Project: Waterloo Over Station Development (Southern Precinct) **Project No:** 46198
To: Patrick Garland **Date:** 15 February 2020
From: Brandon Notaras

RE: Response to Submissions – City of Sydney – Item 34

Figure 1: Updated convergence graph

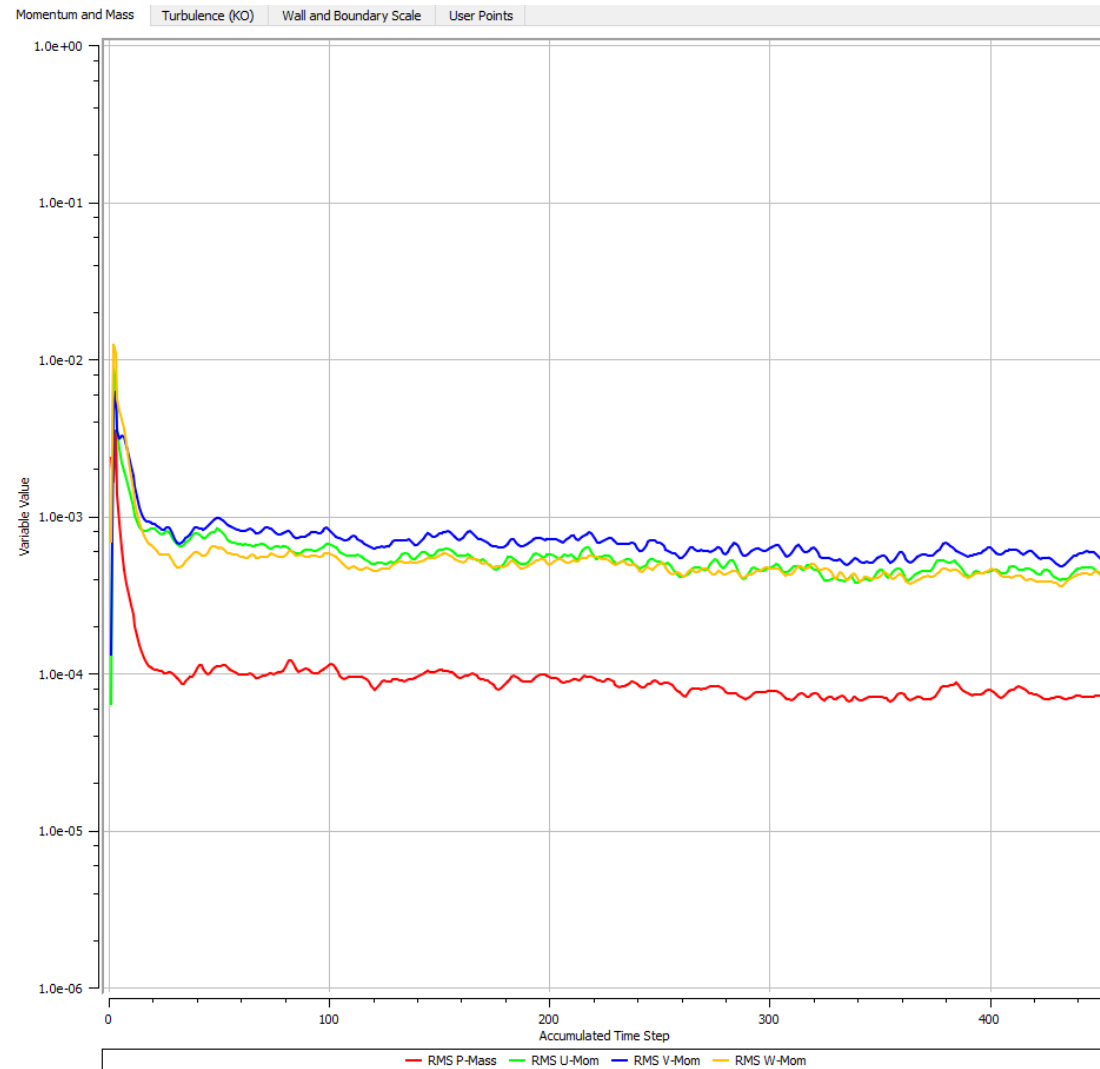
3	A convergence graph is shown for the key variable residual errors. The graph is presented at 300 iterations. It is assumed this is also the timestamp at which the results are taken. The graph shows some initial instability in the calculations, and we recommend additional iterations to confirm that the solution has converged.	Figure 1 within this memo presents the convergence graph with additional iterations requested. Convergence graph provided within the Noise & Vibration Impact Assessment consisted of an extra instability peak because of additional runs that were used to initiate the final run. For the convergence graph provided in Figure 1, we haven't needed to run the model in this manner given it is an update of the original model. The additional iterations confirmed the solution had converged, given the outcome did not change.
4	Results of the CFD calculations are shown for pressures but not airflows or velocity vectors. Airflow plots would add considerable weight and provide confidence to the results.	Velocity contours and velocity vector graphs are presented in Figure 2 and Figure 3 in this document, respectively. The graphs demonstrate the outcome of the modelling has not changed, and provide confidence to the results.

Figure 2: Velocity contour map – acoustic ventilator (in plan)

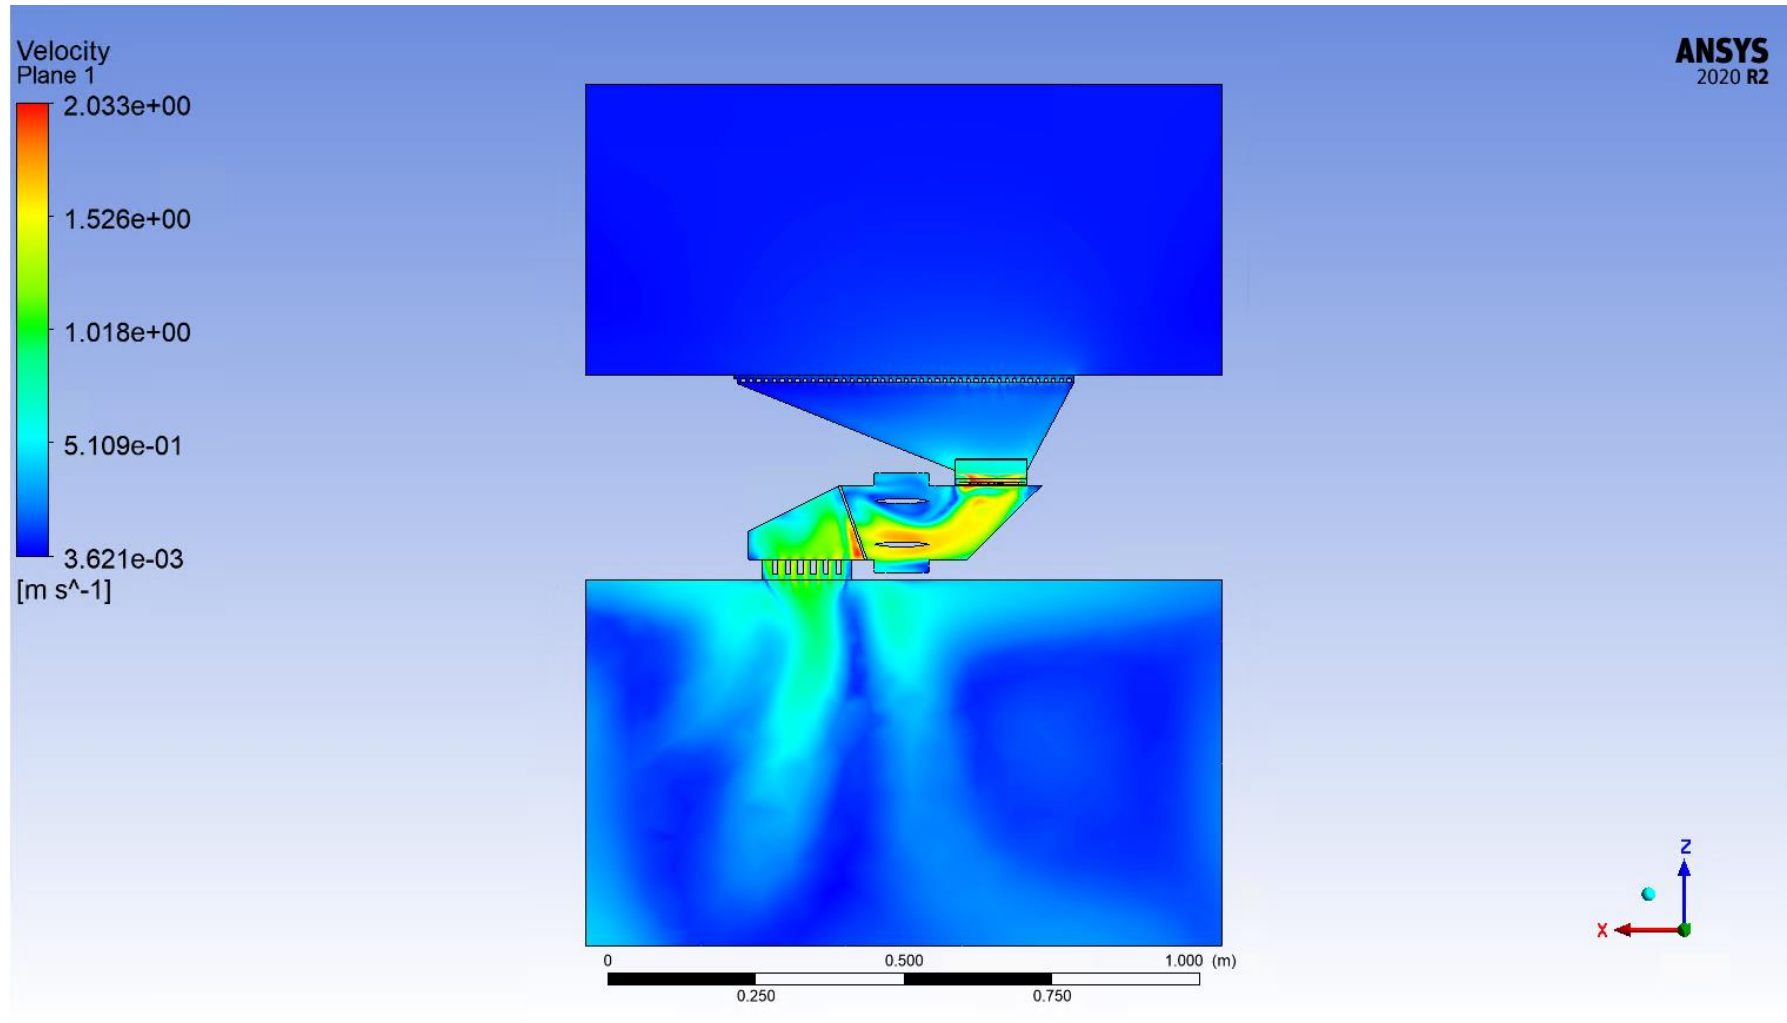
- Further detailed convergence graph showing additional iterations
- Velocity contour and vector graphs requested
- Further detailed acoustic ventilator sketch showing exact dimensions of components to be provided
